## ADDENDUM

| Client / Address | Troy School District<br>4420 Livernois, Troy MI | Project / Location | Former ITT building structured cabling systems |
| Date Issued      | January 21, 2020                                | Project Number     | 9898   |

**A1-1 NOTICE: The bid documents are amended herein which adds to and/or supersedes conflicting or additional information in the Request for Proposal.**

# FIRST FLOOR POWER AND AUXILIARY PLAN

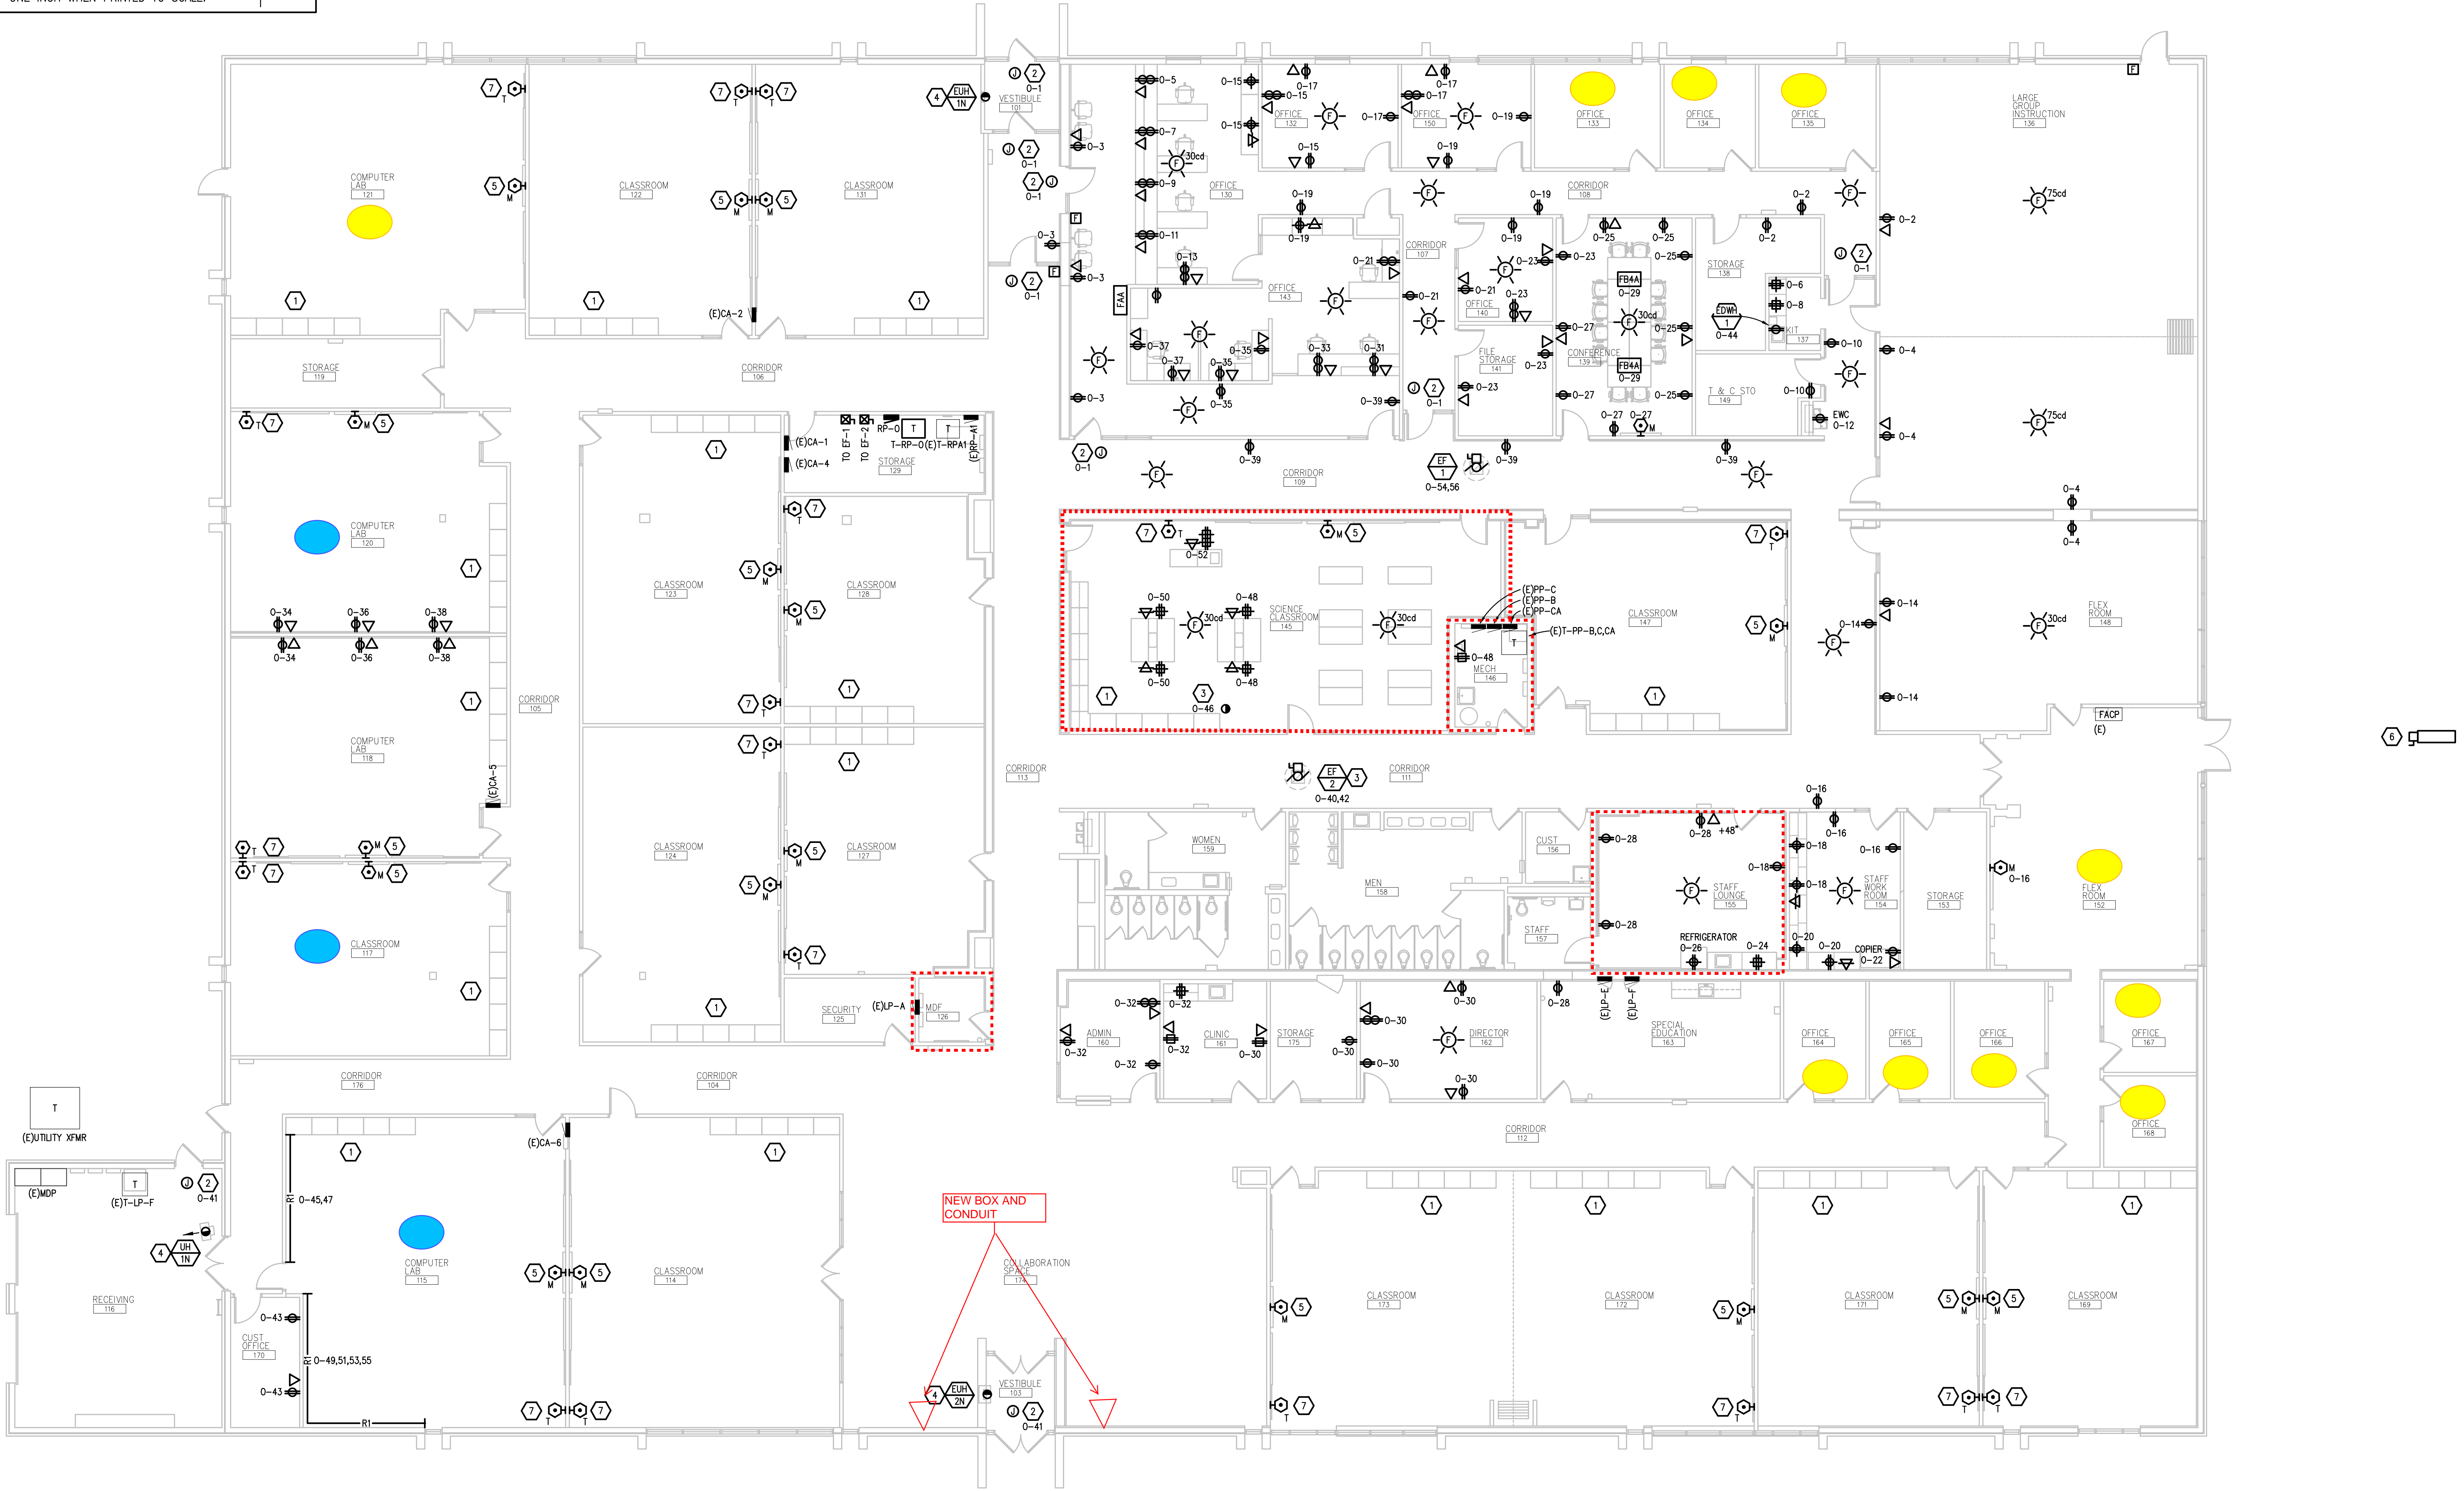
11. Firestopping of new, reused or existing no longer used LV pathway required through fire or smoke rated partitions, see attached drawing
12. MDF Renovation required - New Bonding and Grounding system in MDF required

13. All new cabling Cat6, plenum - General Cable is approved
14. See attached drawing for electrical plan and demolition plan
15. The fire and HVAC systems and associated cabling have been verified that they are currently communicating and functioning. Alarm system and cabling are functional.
